## ORIGINATION FORM

Proposed Revisions to a Standard Plans Index  
(Please provide all information — Incomplete forms will be returned)

Index Number: 715-001  
Sheet Number (s): 1  
Index Title: Conventional Lighting

WIRING DETAILS

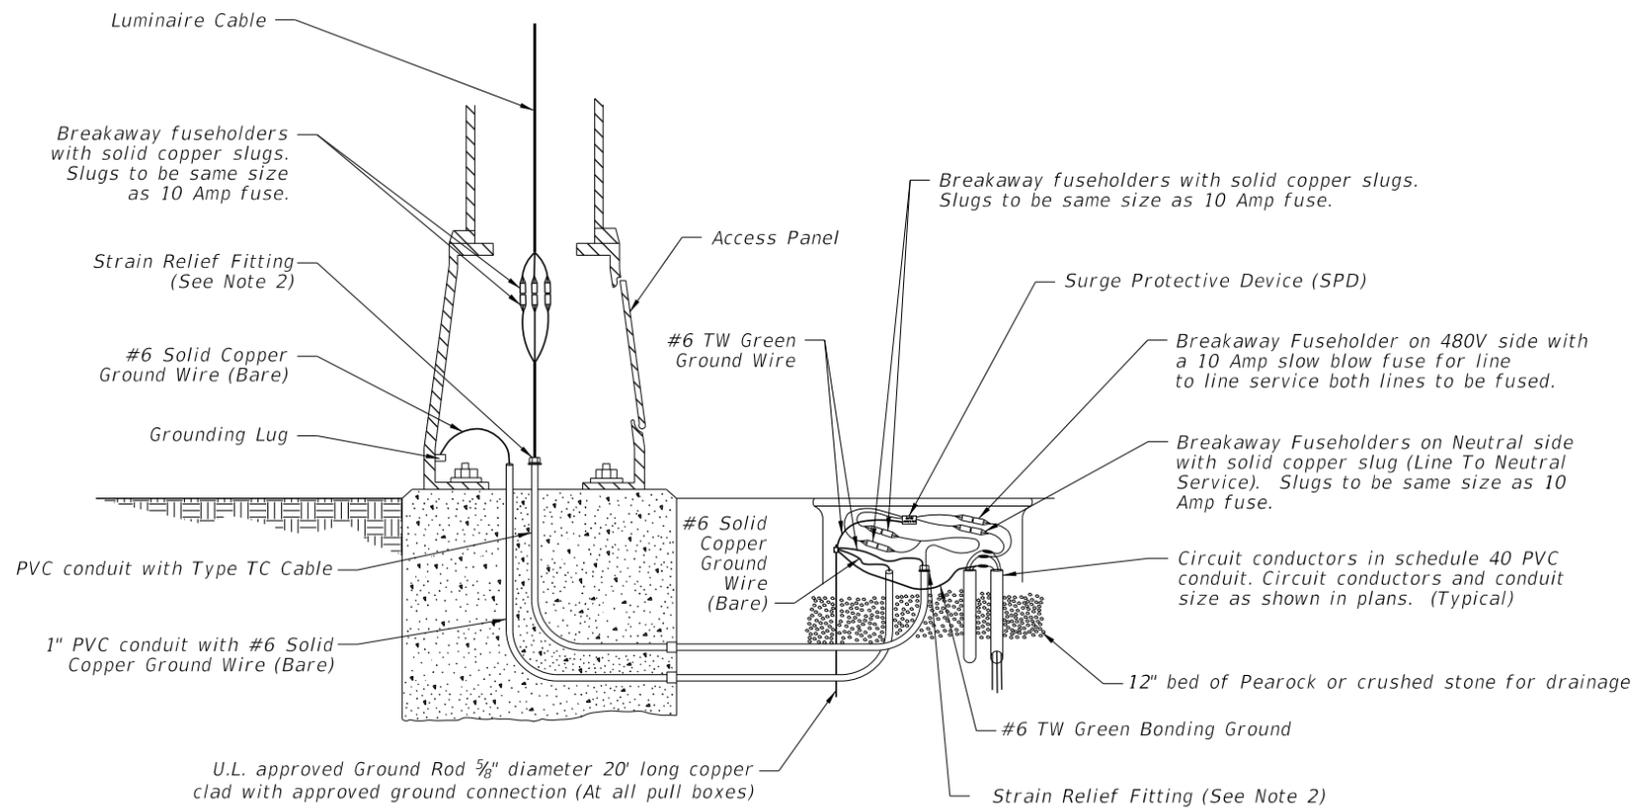
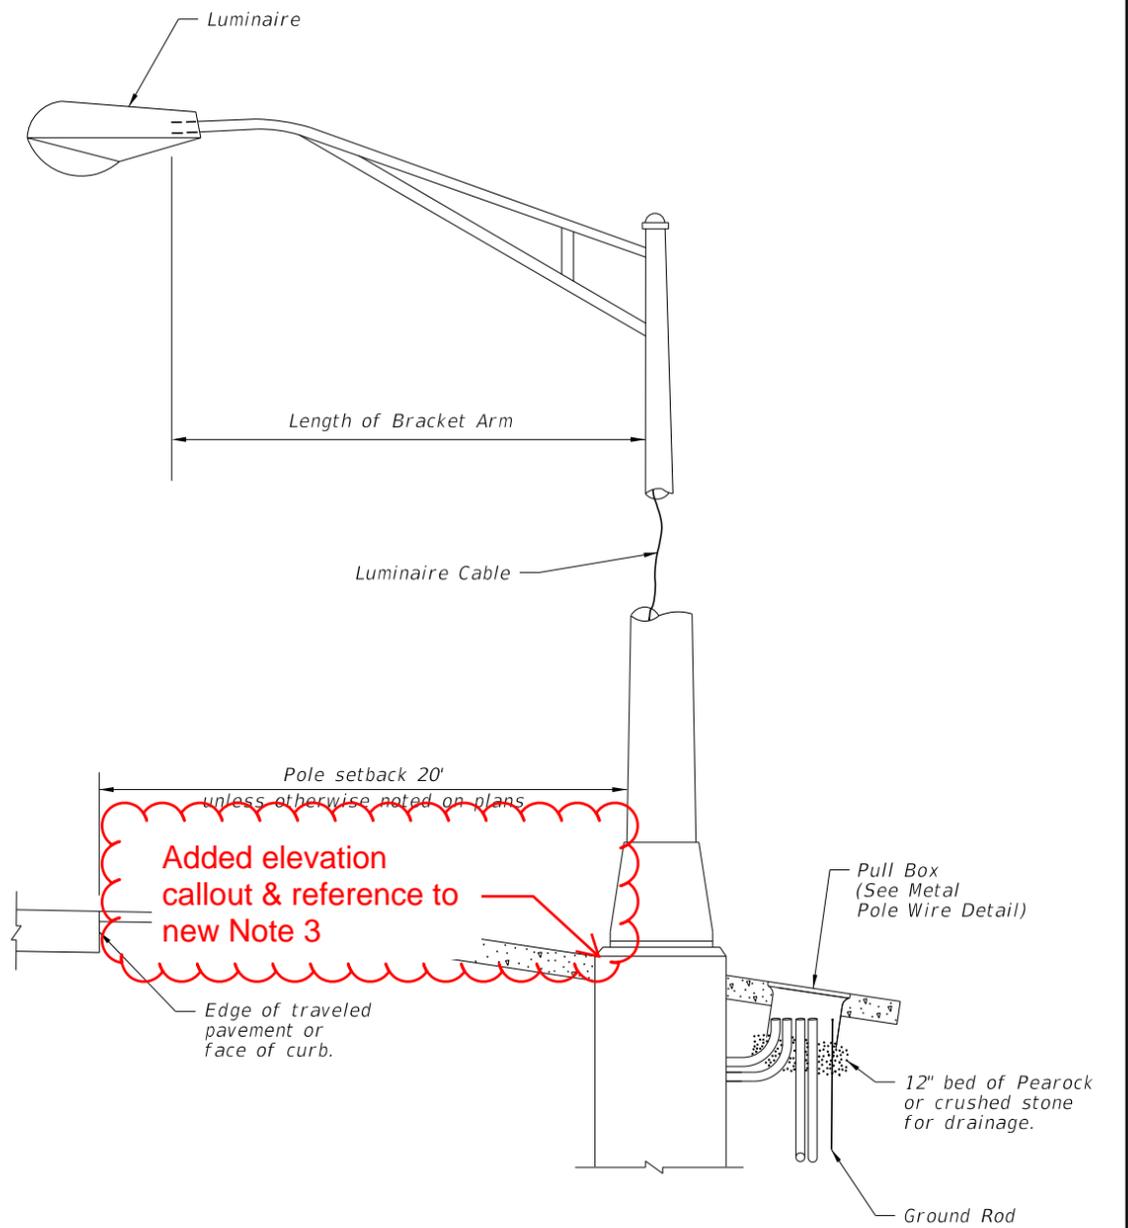
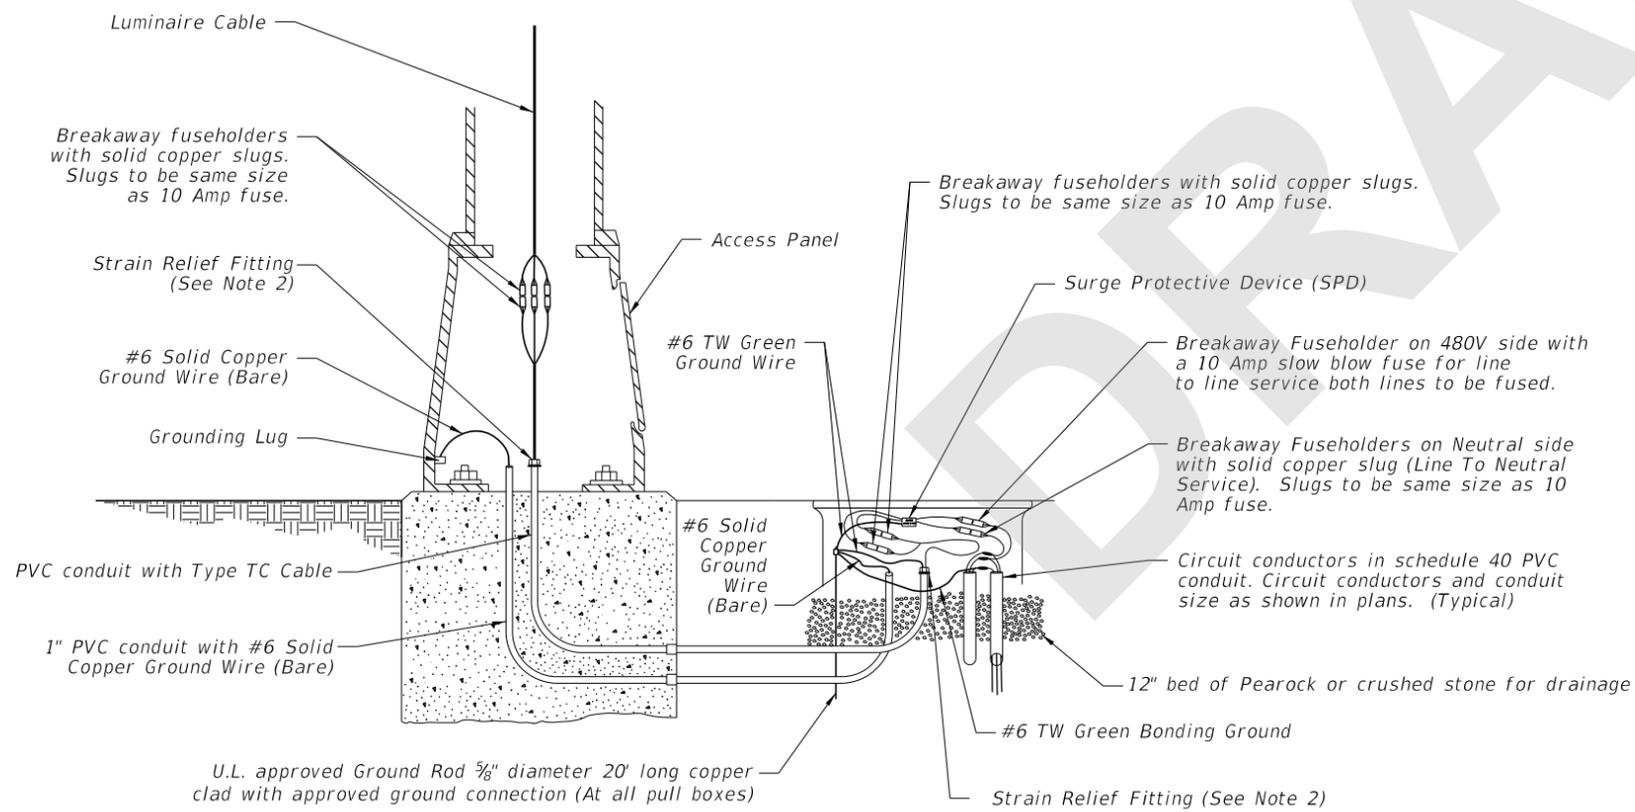
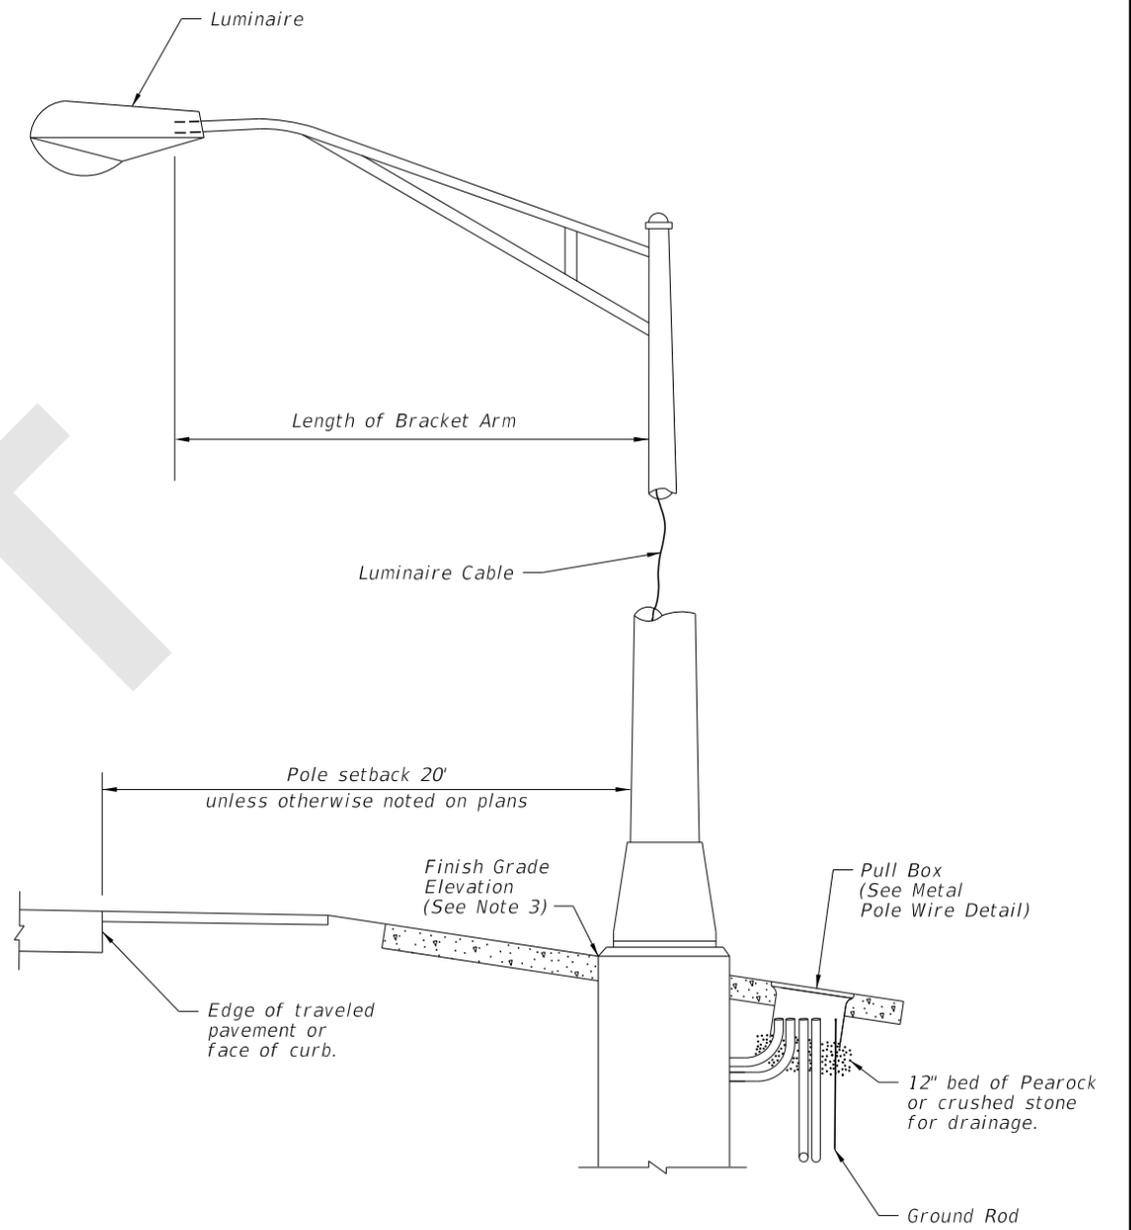
Sheet 1: Updated Note 1 for Concrete Barrier and bridge mount. Provided additional wiring detail, a reference to 715-002, and new information of where breakaway fuse holders fit inside of pole.

Added additional language to clarify wiring for 715-002 including breakaway fuse holder location

1. Concrete Barrier and Bridge Mounted Poles: Place wiring system following conduit layouts and requirements of Index 715-002. Follow additional requirements of Specification 992. For wiring and devices shown inside of pull boxes on this sheet, place inside of embedded junction boxes instead. Place the vertical breakaway fuseholders inside the pole, at the handhole location.

2. Provide enough cable length to allow for removal of fuseholders from the transformer base, pole base, or pullbox for maintenance. Remove slack from the luminaire cable to provide tension on the fuseholders in breakaway pole designs. Pull excess cable into pull box tighten strain relief fittings or cable clamps at both ends of conduit to prevent cable from slipping.

Added callout and new Note 3 to explain that the top of the concrete foundation is flush with the finish grade elevation on the side nearest to traffic lane. Added vertical tolerance.

Added new Note 3 for required foundation elevation.

3. Align concrete foundation with the finish grade elevation on the side nearest the traffic lane. Relative to the finish grade, the vertical tolerance is -0 inch, +2 inch.
